Planning Board
Planning and Urban Development Department
Planning Division
City of Portland
389 Congress St
Portland, ME 04101

Re: 30 Merrill Street

October 4, 2016

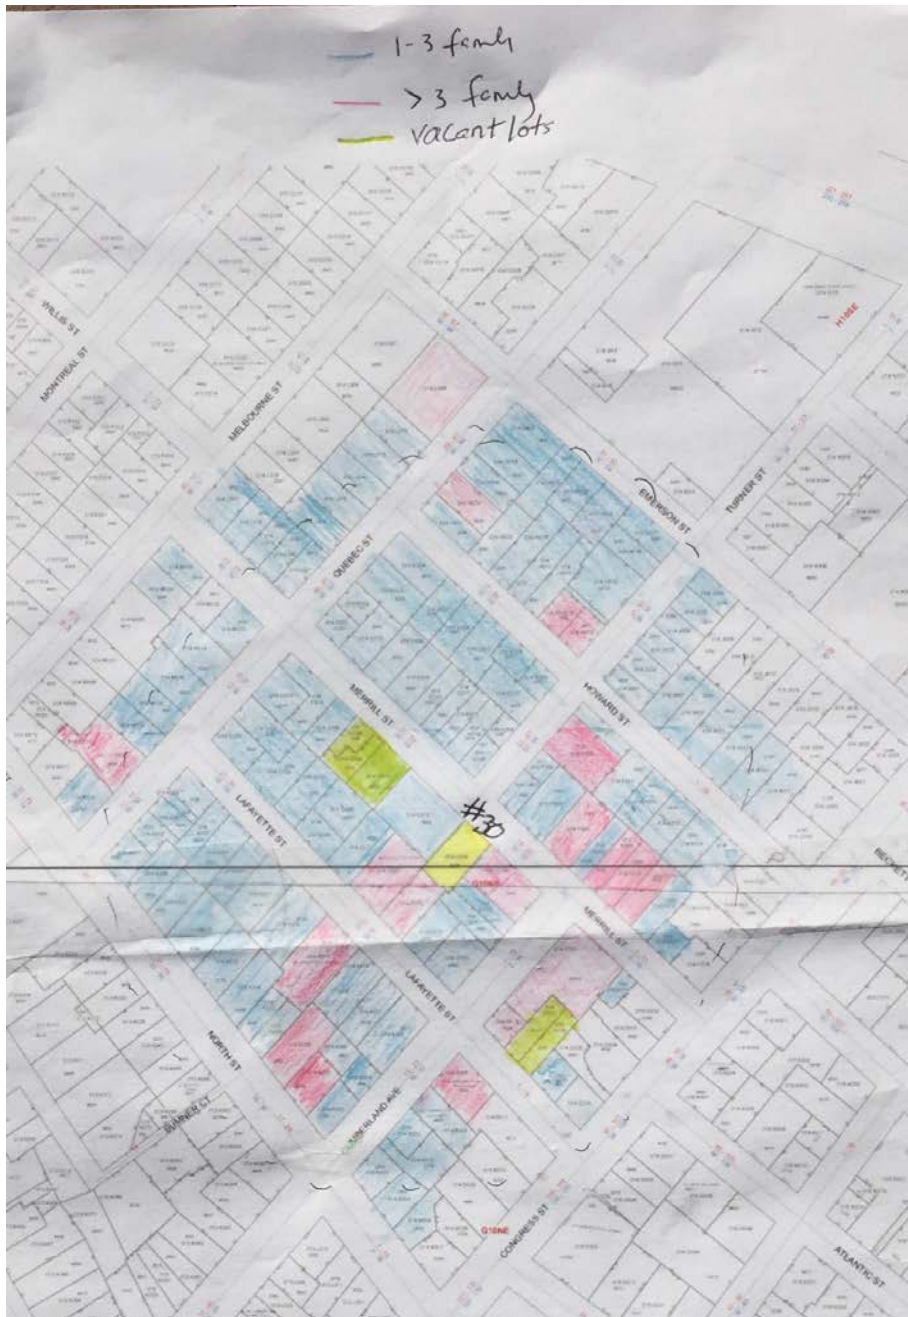
Increased R-6 density means large buildings in neighborhoods of smaller homes. The Board must carefully consider the Design Guidelines in this situation to preserve the character of our neighborhoods.

My overarching concern is the immediate and cumulative effect of allowing construction of large infill buildings that fail to respect the architectural details of the neighborhood. Munjoy Hill is an extremely important neighborhood to the city, drawing a wonderfully diverse

This building does not in any recognizable way reinforce positive features of the surrounding area. Within the block the unique identity of the large buildings to the south are their bays and cornices and mansard roofs, to the north, for the smaller residence are their gable ends, their bays, window shapes and emphasized entrances. It is not impossible to design a larger building that is sympathetic to an existing neighborhood of smaller residences. An excellent example is the new 5-family building at 72 Munjoy Street. Although it is the largest building on the street it, it does not overwhelm the neighborhood; rather, it adopts numerous of the existing characteristics of its neighborhood and employs them in its design.
